6 National Dam Inspection Program.
BEAVER CREEK DAM
(SCS PA 433).

PHASE I INSPECTION REPORT,
NATIONAL DAM INSPECTION PROGRAM

Name of Dam: Beaver Creek Dam
(SCS PA 433)
County Located: Chester County
State Located: Pennsylvania
Stream: Beaver Creek
Coordinates: Latitude 40° 1.8'
Longitude 75° 47.0'
Date of Inspection: March 25, 1980

FIELD OBSERVATION PLAN
BEAVER CREEK DAM

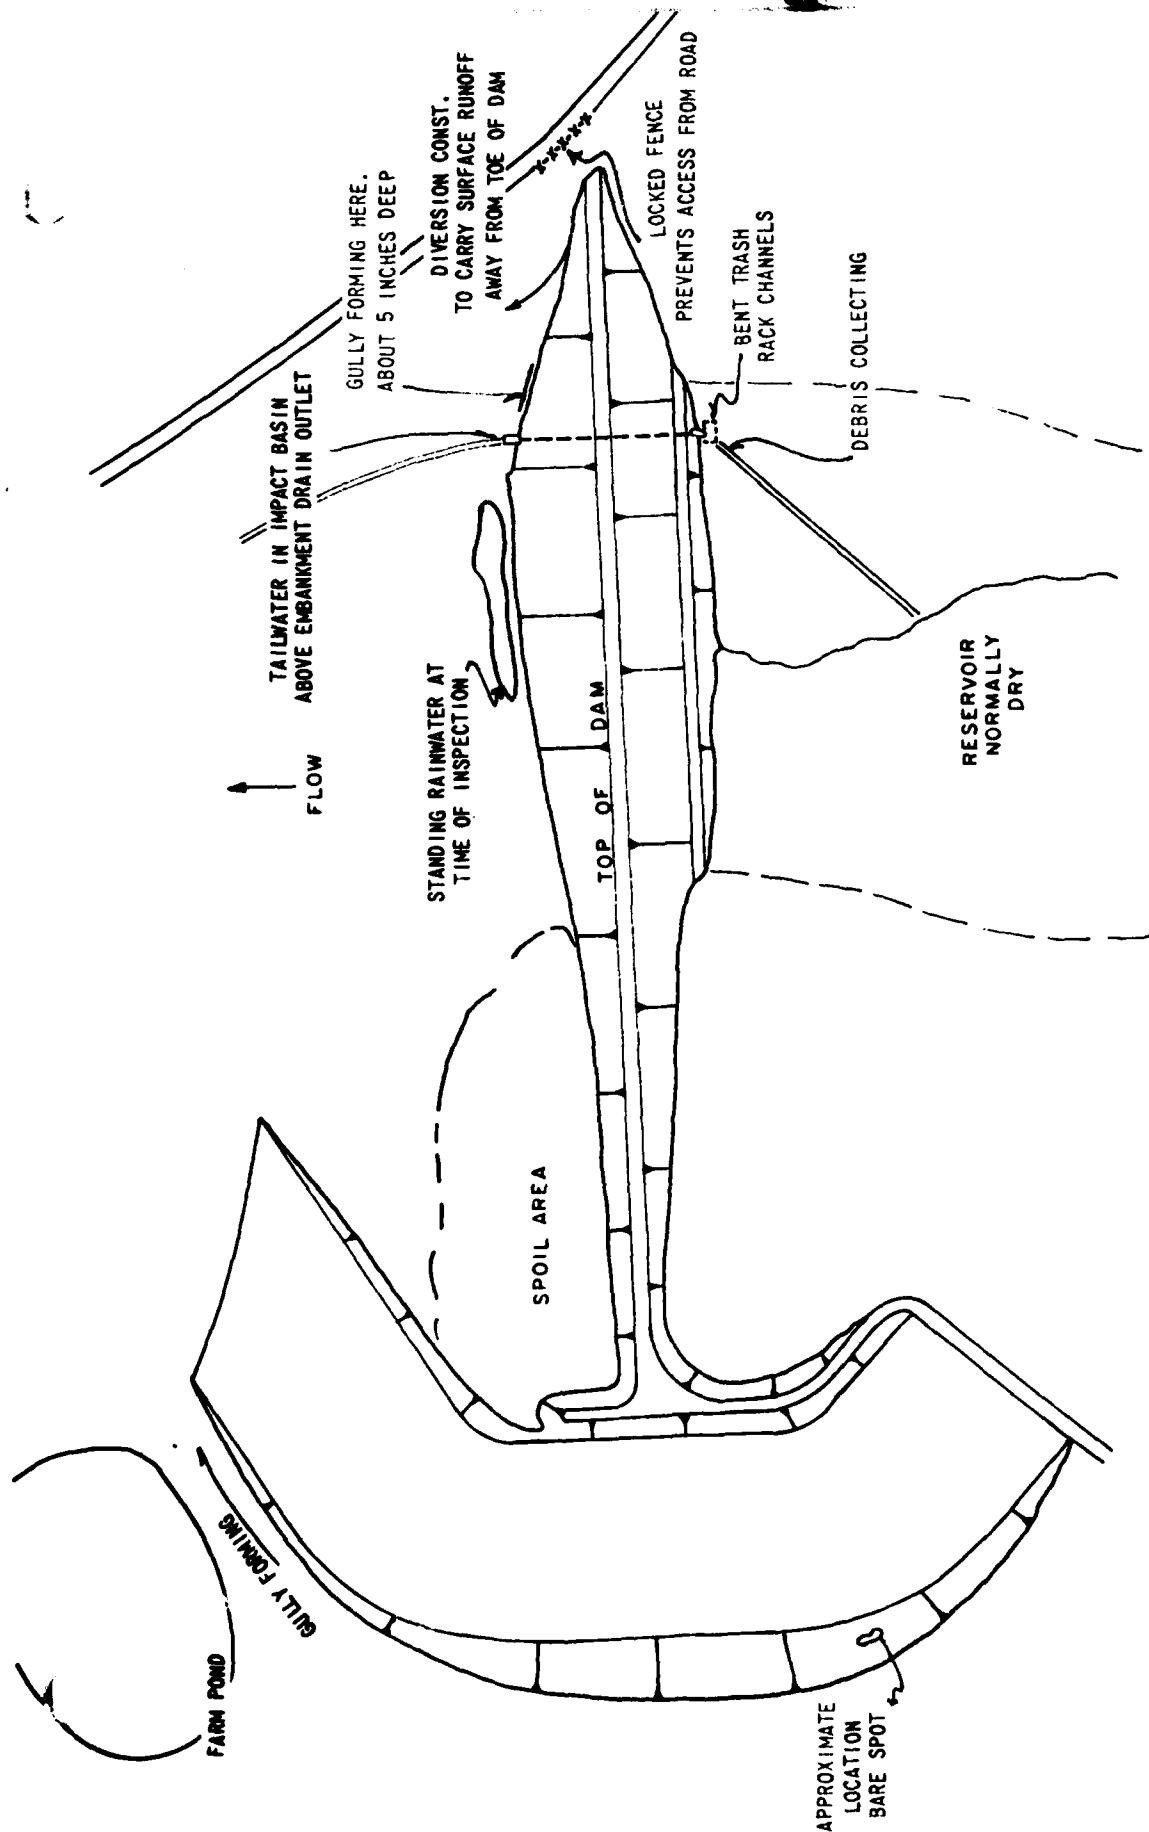
Upstream junction of embankment and right abutment in good condition. A small gully has started in the lower two-thirds of the downstream junction. The downstream junction between the embankment and left abutment appears to have a path worn through the vegetation but no damage to the embankment.
